Submittal via email to [ndpsc@nd.gov](mailto:ndpsc@nd.gov)  
Case Number: PU-14-105

Re: Sunflower Wind Project – Crane Travel Path

## Revised Crane Path Exhibit

**Attachment 1 - Turbine 8 to Turbine 9 Temporary Crane Path Re-Route**

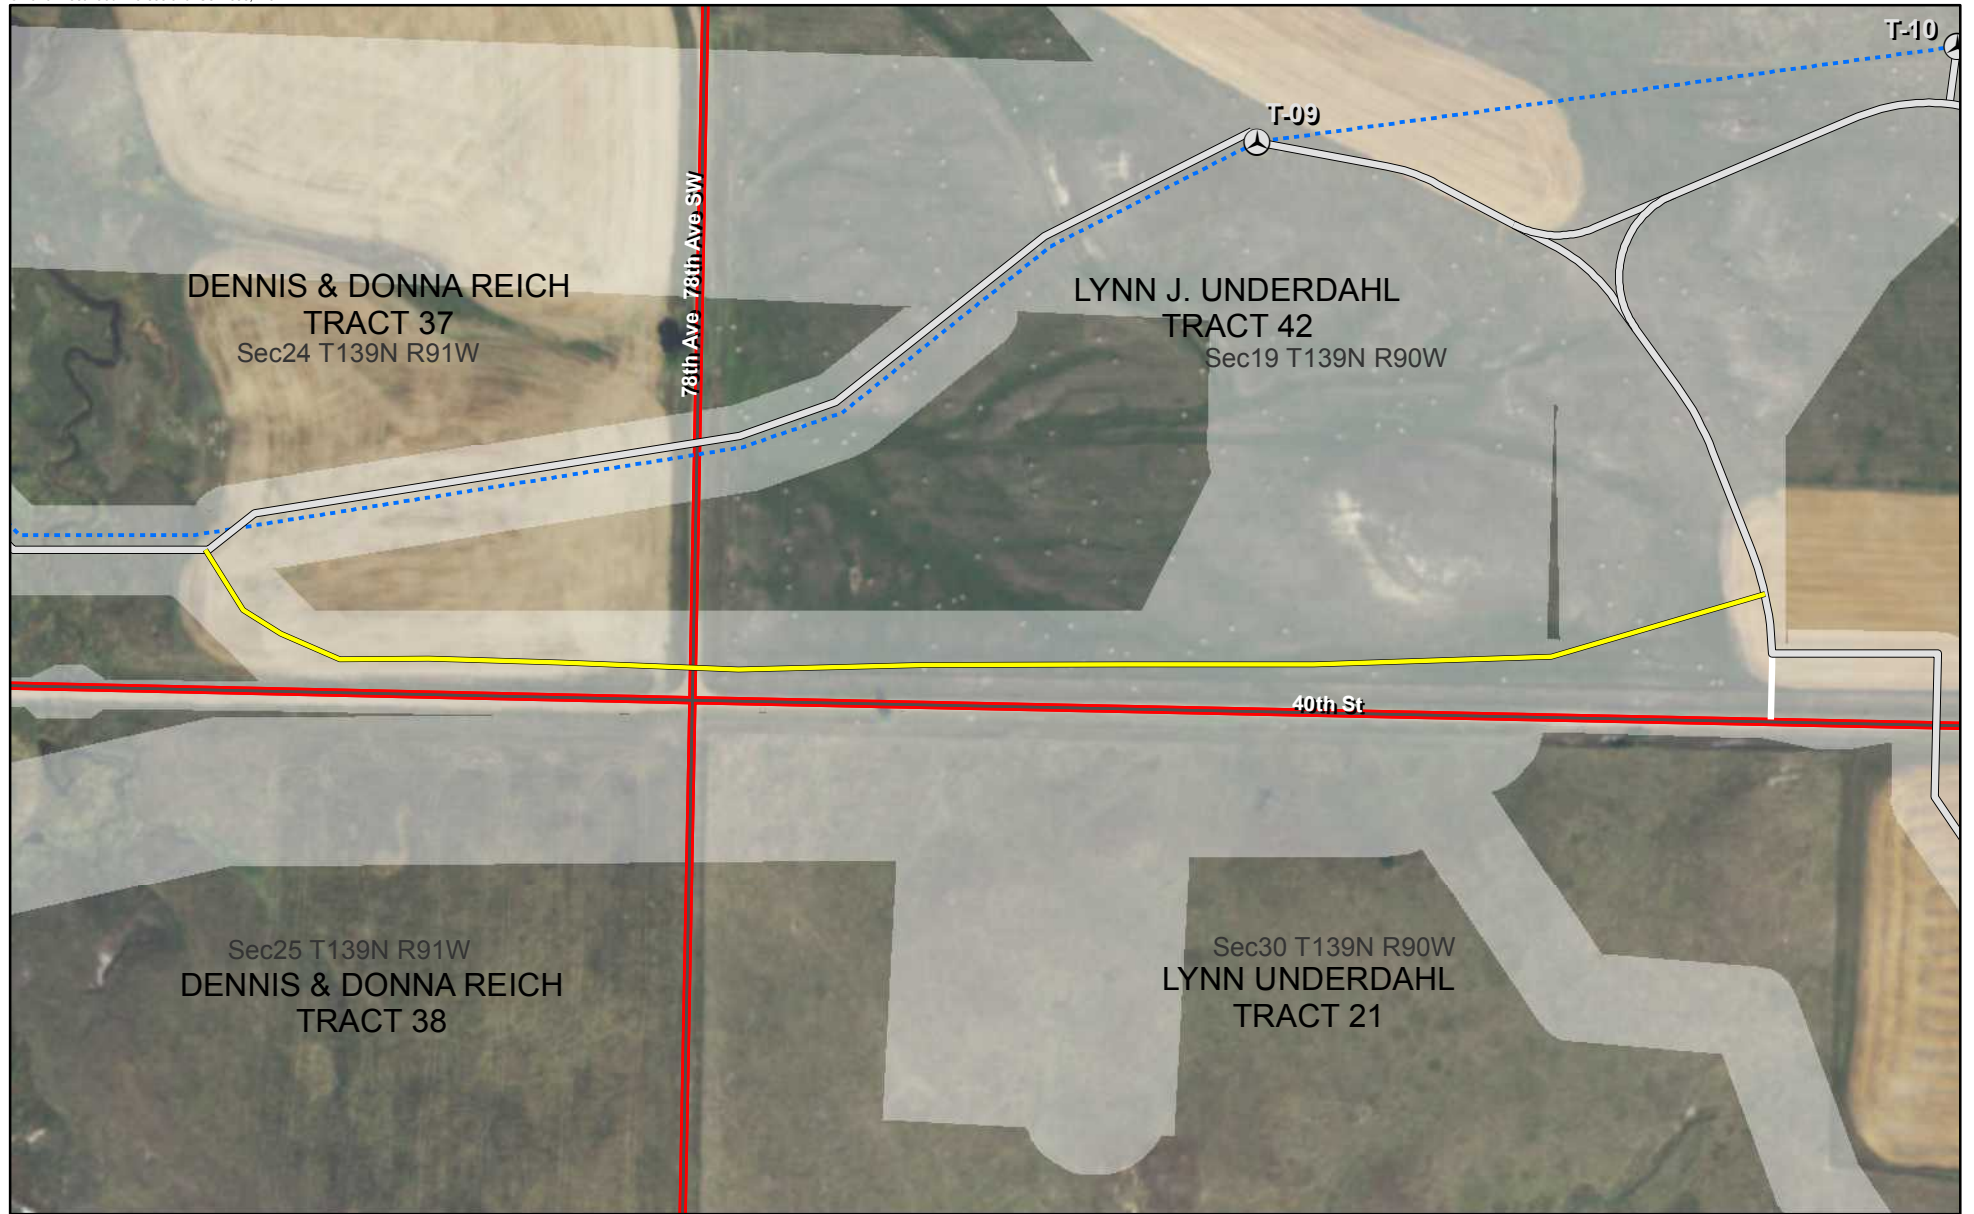
1. Reroute the crane travel path between turbine 8 and turbine 9 as shown in Attachment 1 to reduce the amount of topography the crane has to travel and follow the property boundary rather than cutting across a field. This change is for the temporary crane travel path within the leased disturbance area, remains within the culturally surveyed corridor and will not affect any exclusionary or avoidance areas.

**Attachment 2 - Turbine 11 to Turbine 25 Temporary Crane Path Re-Route**

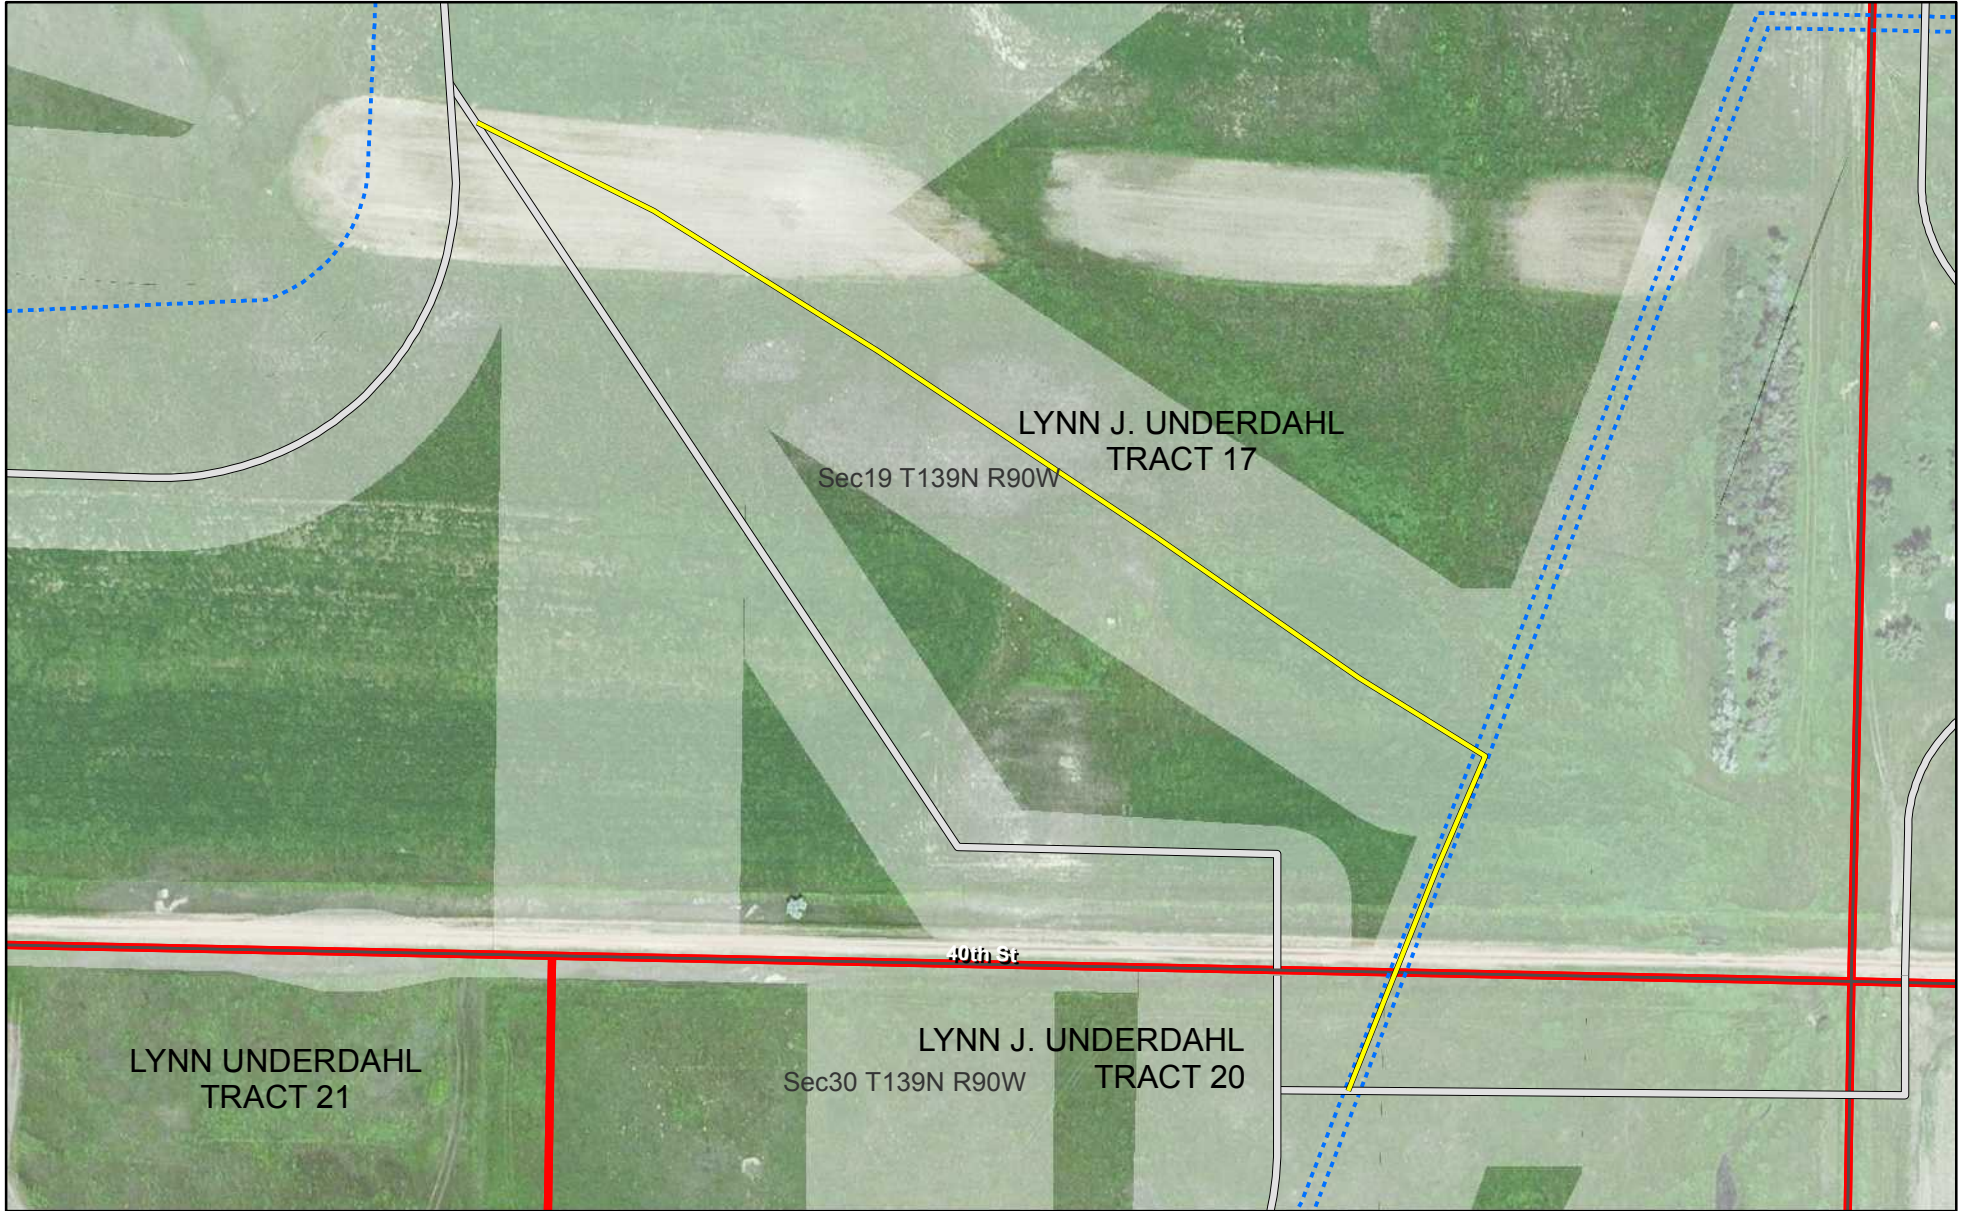
2. Reroute the crane travel path between turbine 11 and turbine 25 as shown in Attachment 2 to reduce the amount of topography and cut to fill work the crane has to travel. This change is for the temporary crane travel path within the leased disturbance area, remains within the culturally surveyed corridor and will not affect any exclusionary or avoidance areas.

**Attachment 3 - Turbine 29 North up County Road 90 for Temporary Crane Path  
Re-Route**

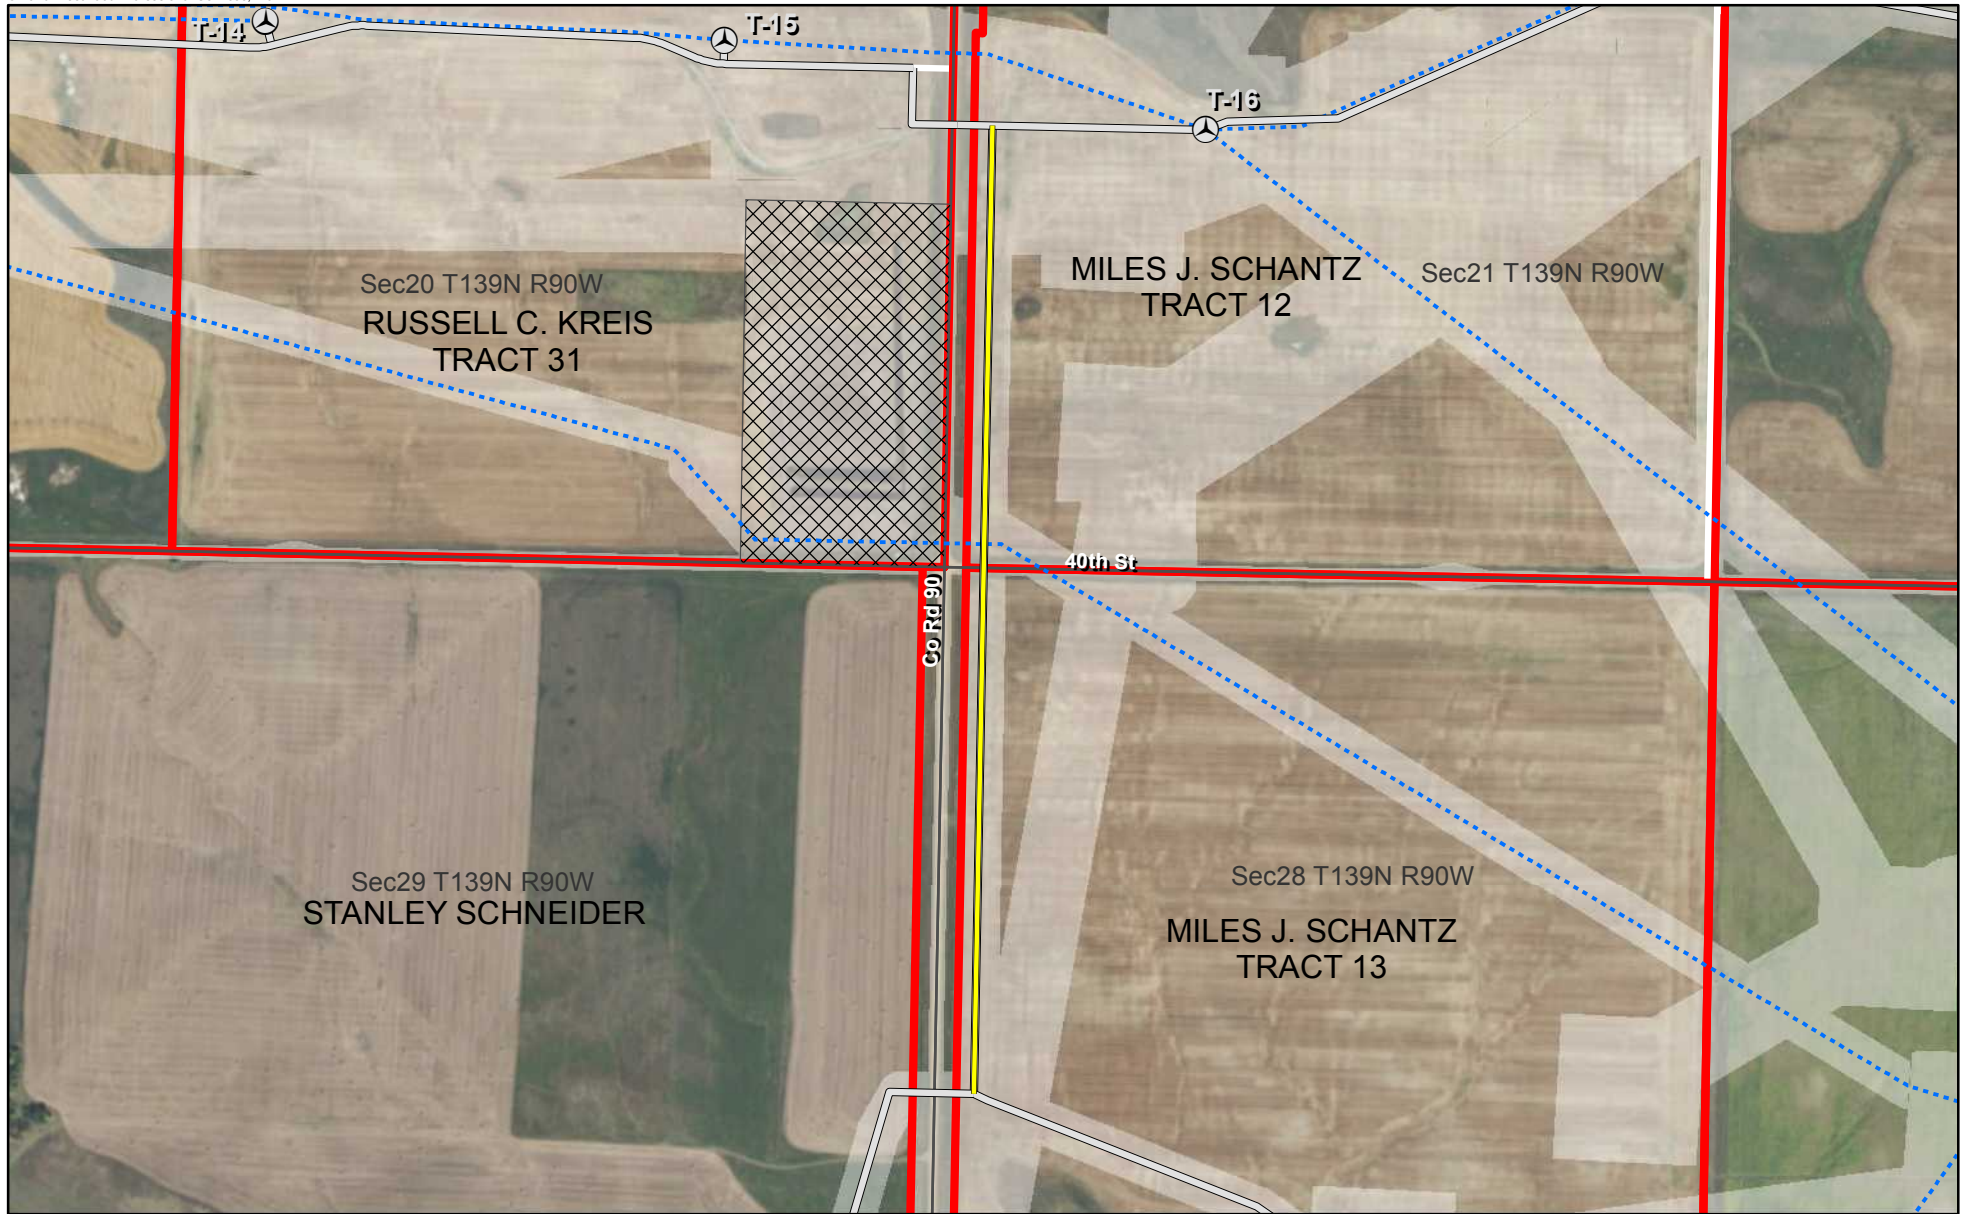
3. Reroute the crane travel path from turbine 29 north along County Road 90 as shown in Attachment 3 to reduce the amount of topography the crane has to travel and follow the property boundary rather than cutting across a field. This change is for the temporary crane travel path within the leased disturbance area, remains within the culturally surveyed corridor and will not affect any exclusionary or avoidance areas.
